Oil Pressure Message in Instrument Cluster on New Vehicles

Topic number	LI18.40-P-073054
Version	2
Function group	18.40 - Oil level/oil pressure sensor
Date	7/27/21
Validity	All vehicles with M139 transverse
Reason for change	Updated for clarity
Reason for block	Pending clarification

Hydraulikventil		Position of hydraulic valve

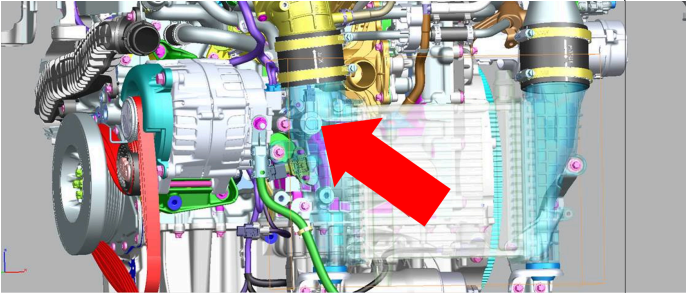
Sporadic warning message in instrument cluster "No oil pressure - switch off engine" (or similar) is shown in red on vehicles with low mileage.

Directional control valve may stick.

Install new hydraulic valve A 654 180 44 00. Tightening torque: 20 Nm
